**TRUCK UTILITY LT GS CARGO LANDROVER SERIES 3  
STRENGTHENING OF SPOT WELDED SEAMS – STOWAGE BINS  
MODIFICATION INSTRUCTION**

1. This instruction details the strengthening of the spot welded seams that support the floor of the stowage bins.

FIG 1 - LINE OF RIVETS (UNPAINTED)

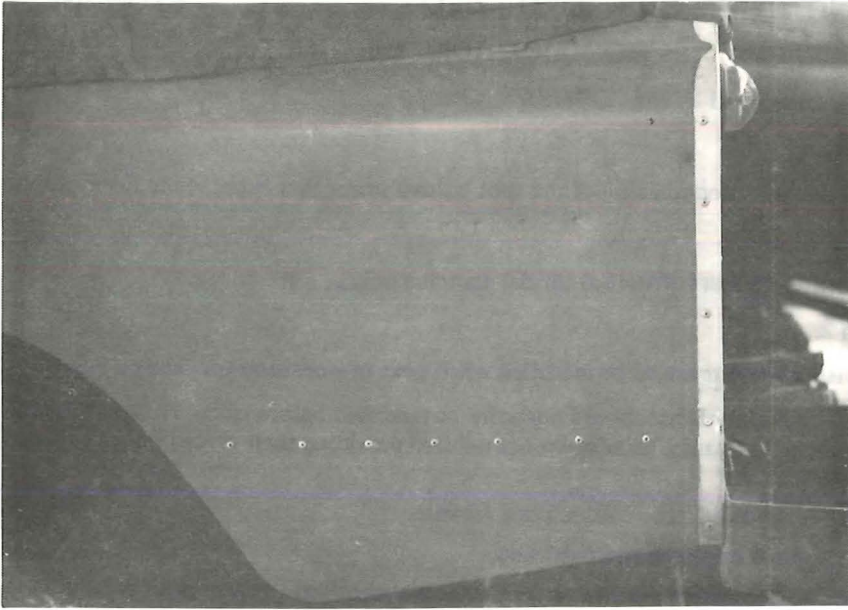
7. Modification procedure is as follows:
  - a. Refer to Fig 1 and drill seven 5 mm diameter holes equally spaced along the spot weld line of the floor of the stowage bin. Do not drill through the spot welds.
  - b. Rivet the drilled panels using item 1 from Table 1.
  - c. Paint the rivet heads in accordance with WKSP B 700.
  - d. Manufacture two floor boards as shown in Fig 2 using item 2 from Table 1. Prime and paint black in accordance with WKSP B 700.
  - e. Fit the boards in the stowage bins.
